MEMORANDUM FOR: Docket File Nos. 40-8981; 40-8958

SUBJECT: SAFETY EVALUATION REPORT (SER) FOR URANERZ U.S.A., INC.,
RUTH AND NORTH BUTTE PROJECTS

UNITED STATES NUCLEAR REGULATORY COMMISSION
SAFETY EVALUATION REPORT
PREPARED BY THE
URANIUM RECOVERY FIELD OFFICE
IN CONSIDERATION OF AN APPLICATION FOR TWO
SOURCE MATERIAL LICENSE'S FOR
URANERZ U.S.A., INC.
RUTH AND NORTH BUTTE COMMERCIAL IN-SITU LEACH OPERATIONS
LOCATED IN
JOHNSON COUNTY AND CAMPBELL COUNTY, WYOMING
DOCKET NO. 40-8958, SOURCE MATERIAL LICENSE SUA-1539
DOCKET NO. 40-8981, SOURCE MATERIAL LICENSE SUA-1540

The Ruth Satellite Facility

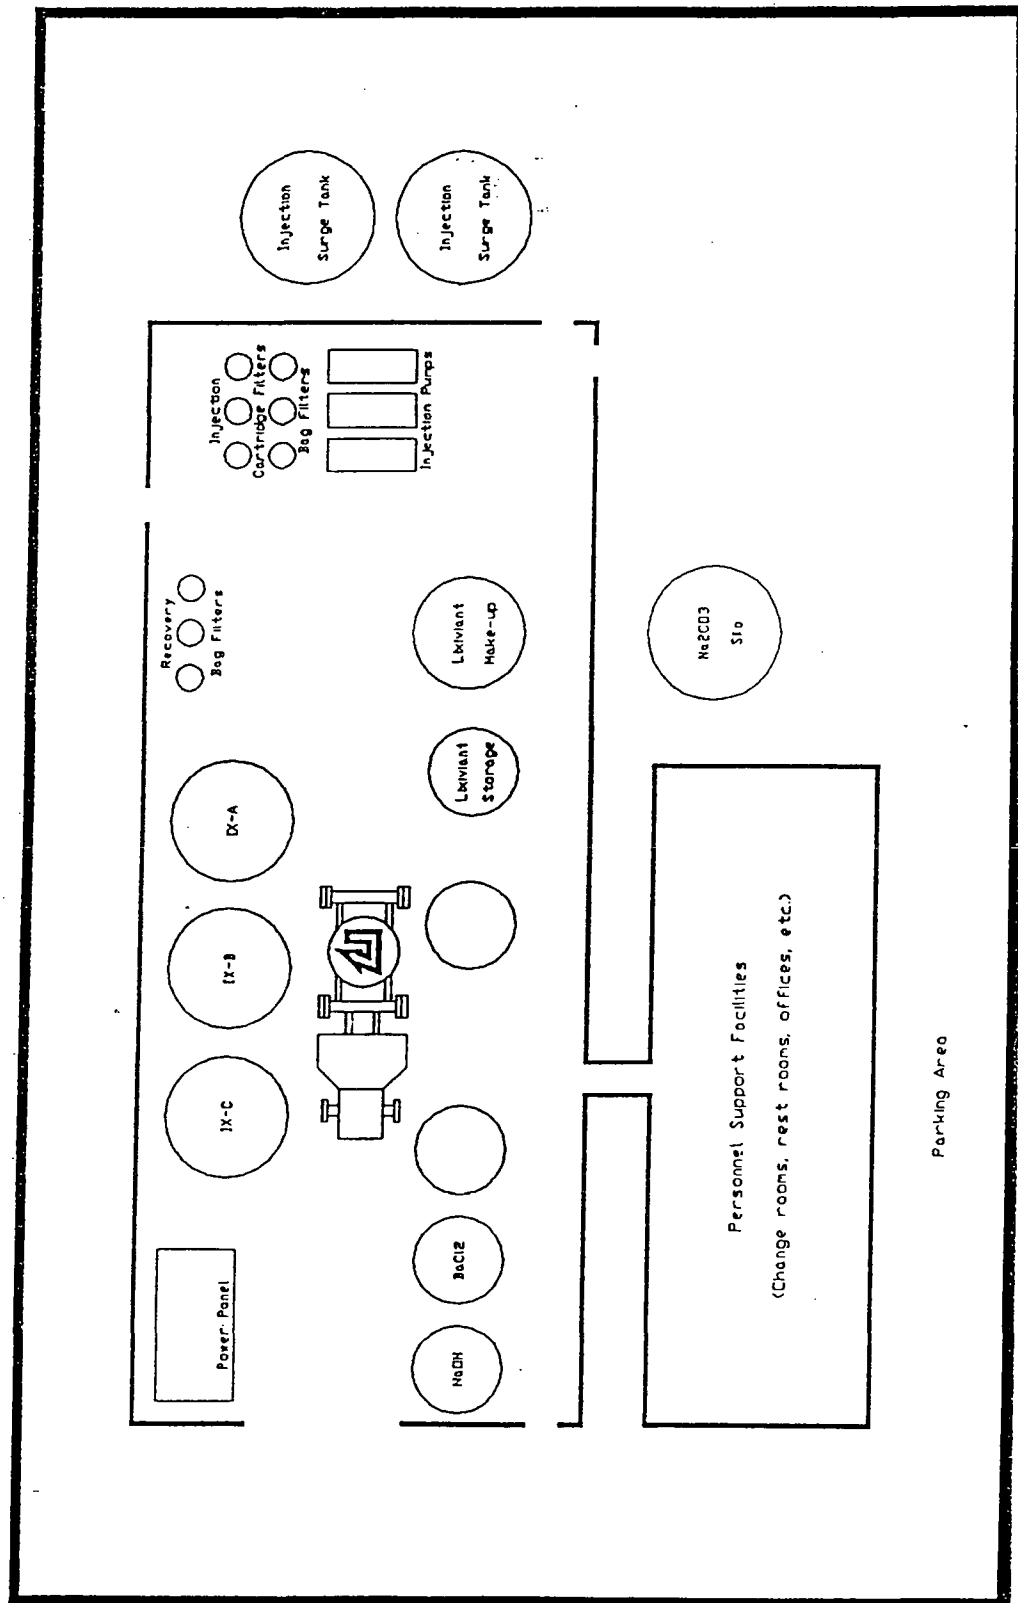
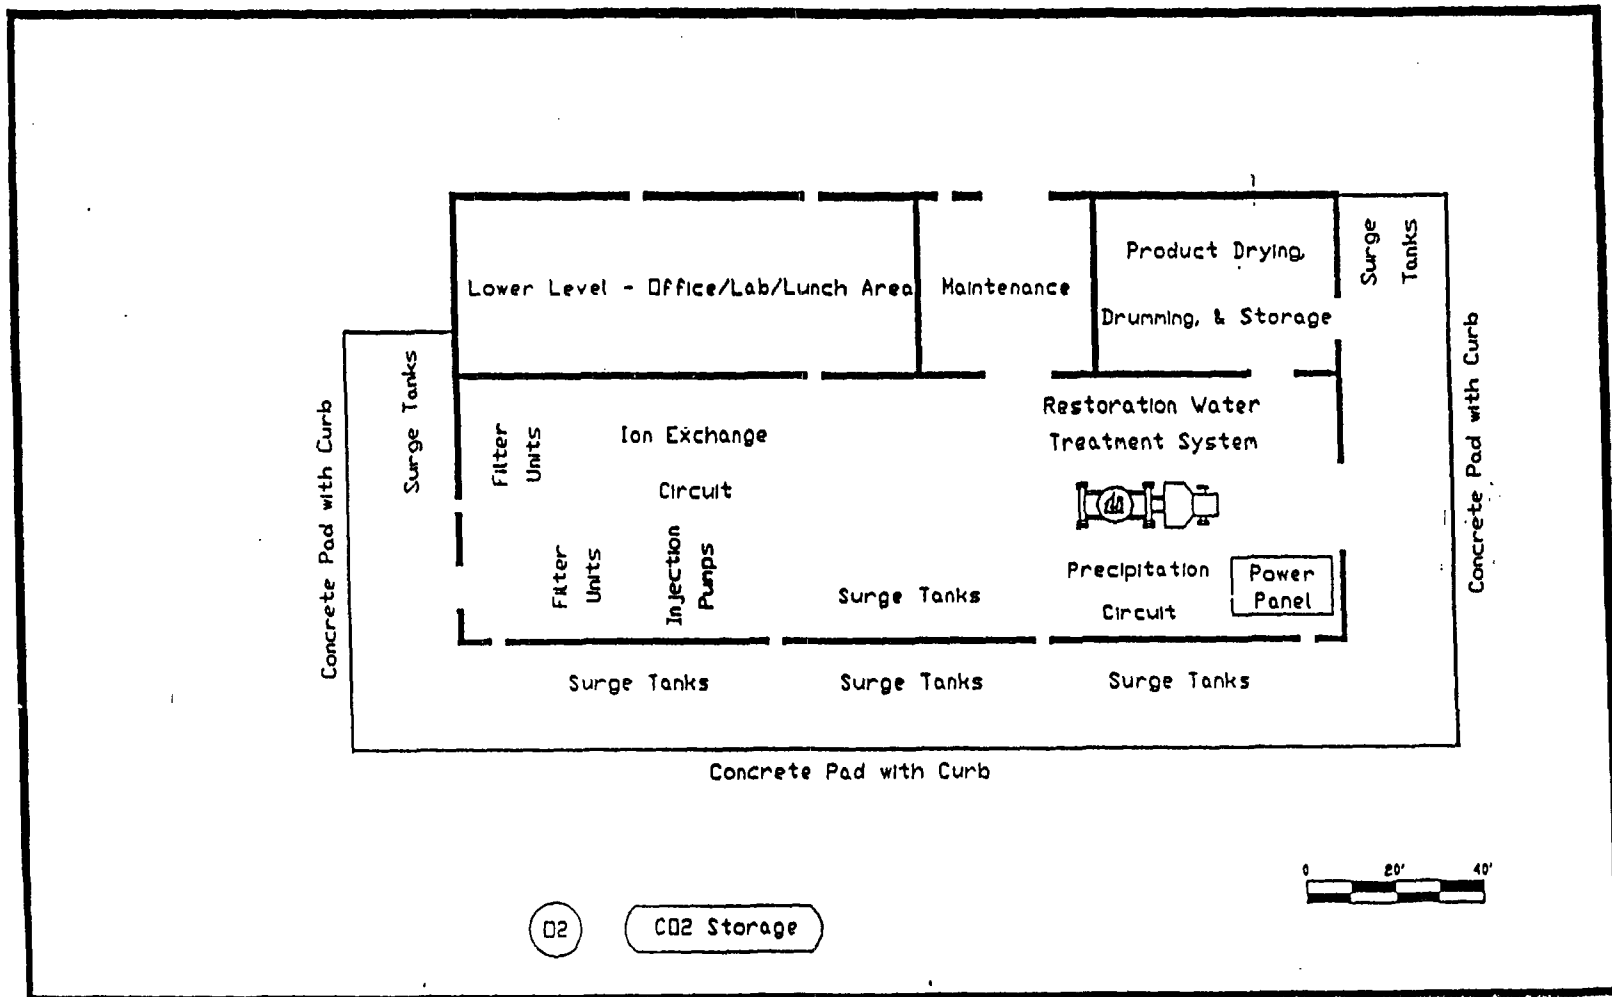
The Ruth site will be a 1000-gpm satellite facility that will rely on the North Butte main processing plant for yellowcake drying and packaging. Operations at the Ruth site will occupy the building that currently exists from the former Ruth R&D site. Similarly, the solar evaporation ponds that currently exist at the Ruth R&D site will be utilized for waste water disposal. Well field development will concentrate on the more heavily mineralized portions of the ore deposit. The plant configuration is shown in Figure 2.2.1.

The configuration of this process circuit is typical for this type of uranium recovery operation. To assure that the process circuit is not changed without adequate health and safety considerations, the licensee will be required by license condition to submit any proposed circuit change to the configurations shown in Figures 2.2.1 and 2.2.2, to the NRC for review and approval.

- ° Any significant changes in the process circuit as show in Figure 15.19 of the application, dated October 3, 1988, shall require approval by the NRC, Uranium Recovery Field Office, in the form of a license amendment.

Figure 4.2.1

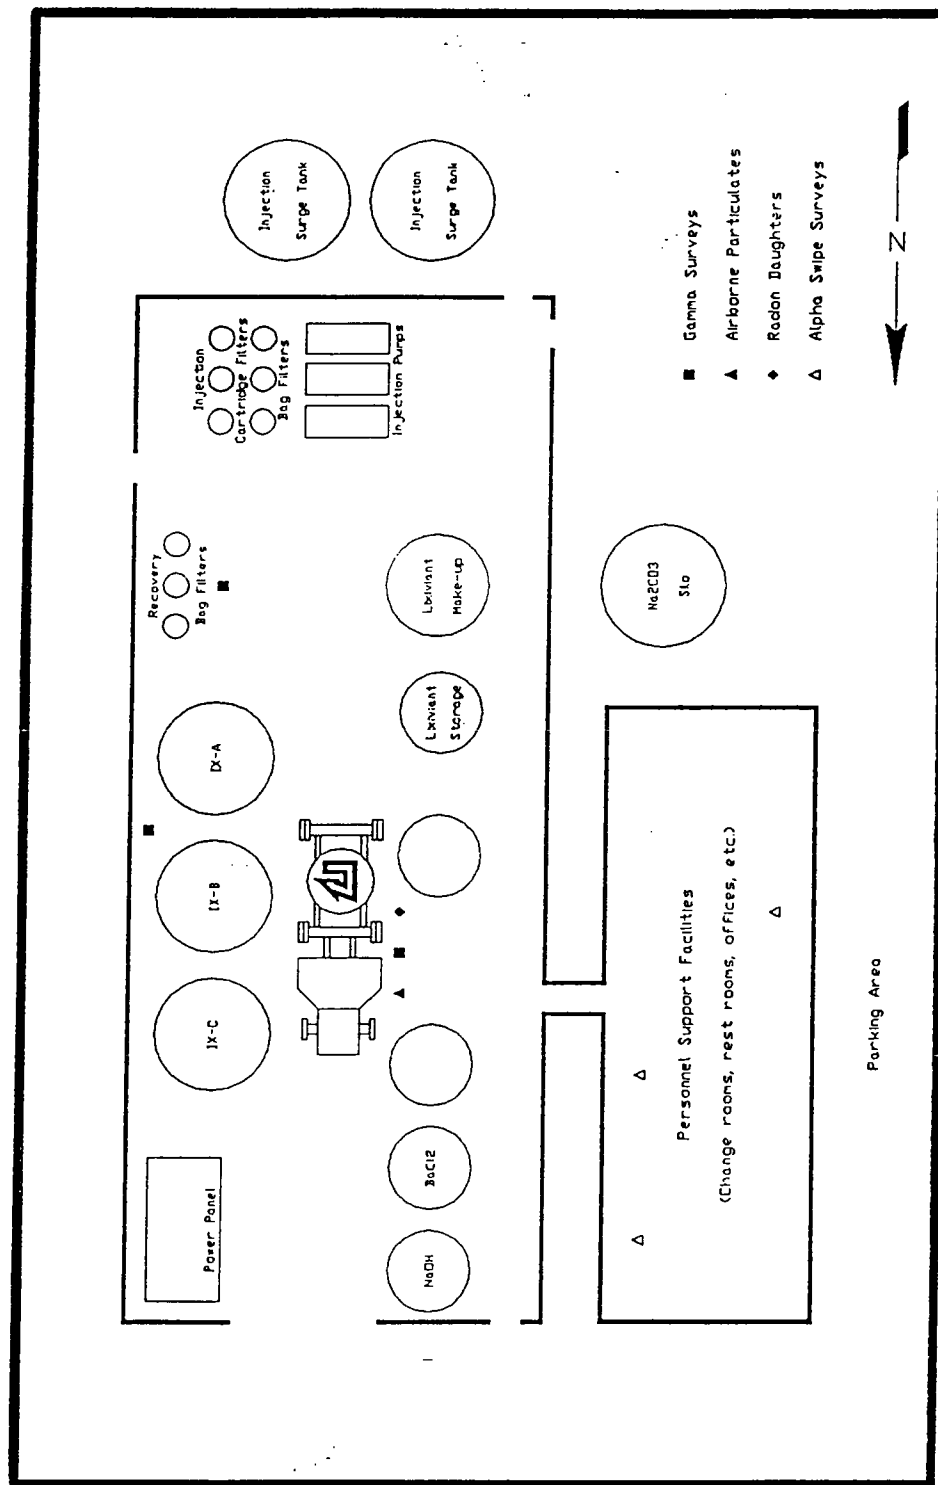
The various monitoring locations at the Ruth and North Butte facilities are shown on Figures 4.2.1 and 4.2.2 respectively. These monitoring locations with the frequencies specified above will be required by license condition.

Uranerz has proposed to conduct gamma exposure rate surveys at the Ruth site on a semiannual frequency and at the North Butte facility on a quarterly frequency. The surveys will be performed at the locations shown in Figure 4.2.1 and 4.2.2. Because these are new facilities and there is an unknown potential for gamma exposures, due to solutions high in radium, the frequencies proposed by Uranerz are not adequate. Uranerz will, therefore, be required by license condition to perform gamma surveys on a monthly frequency for both the Ruth and North Butte sites. After the sites have been characterized and if the data supports it, a reduction in monitoring frequency may be appropriate after review and approval by NRC.

- ° The licensee shall implement the radiological surveys specified in Sections 19.1.7.2, 19.1.7.5, 19.1.7.6, and 19.1.7.8 at the locations specified in Figure 19.2 of the application dated, October 3, 1988. Additionally, alpha surveys, at the designated locations shall be conducted weekly and gamma surveys shall be performed monthly.

- ° The licensee shall implement the radiological surveys described in Sections 19.1.7.2, 19.1.7.5, 19.1.7.6, and 19.1.7.8 at the locations specified in Figure 19.2 of the application dated, March 7, 1989.
